Docket Number:	09-AFC-06C
Project Title:	Blythe Solar Power Project - Compliance
TN #:	233004
Document Title:	BSPP Petition To Amend - Site Boundary Modification
Description:	N/A
Filer:	Scott Galati
Organization:	DayZenLLC
Submitter Role:	Applicant Representative
Submission Date:	5/17/2020 8:03:37 PM
Docketed Date:	5/18/2020

BLYTHE SOLAR POWER PROJECT
SITE BOUNDARY MODIFICATION
PETITION To AMEND

Submitted by:
NextEra Blythe Solar Energy Center, LLC

May 2020

FIGURE - 1

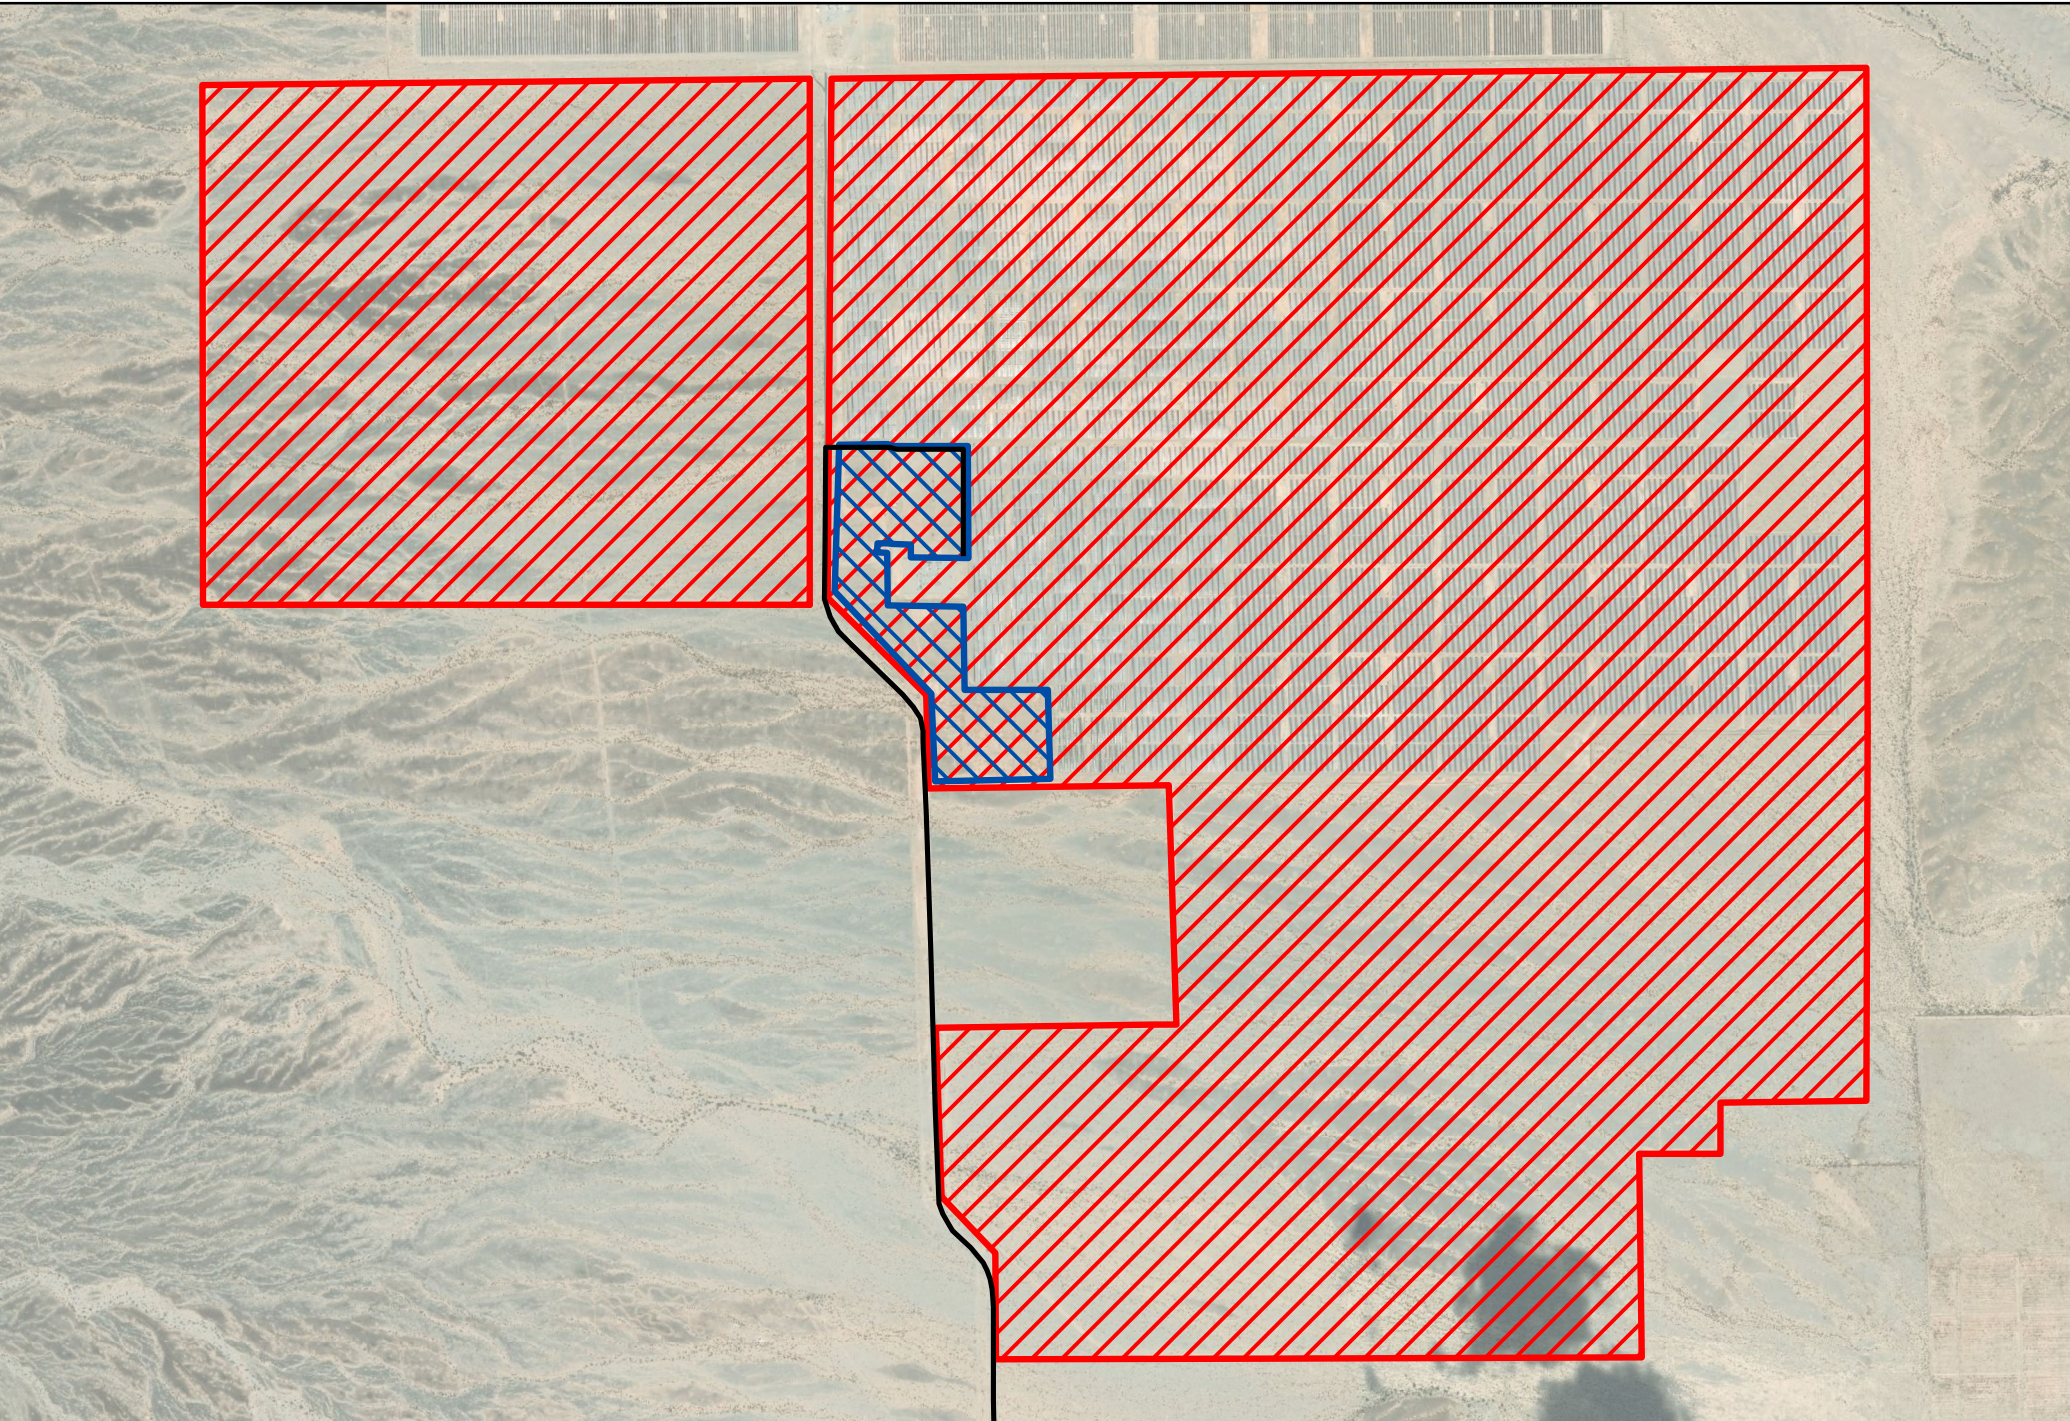
This PTA requests the site boundary be modified to eliminate approximately 94 acres of vacant land located in the western portion of the current shared facilities area from the CEC Final Decision. As discussed in this PTA, the modification of the site boundary will not result in any significant environmental impacts and no modifications to the Conditions of Certification are necessary.

The BSPP is located at 1000 Dracker Drive, Blythe, California 92225 in Riverside, California, on land administered by the Bureau of Land Management (BLM). The total acreage of the BSPP, as identified in the CEC Final Decision, is approximately 4,070 acres. This PTA seeks to modify the site boundary by relocating the western boundary of the shared facilities area as shown on Figures 1 and 2. The total acreage that would be eliminated from the Project Description would be approximately 94 acres of vacant land, thereby modifying the total acreage of the CEC Site to be approximately 3,976 acres.
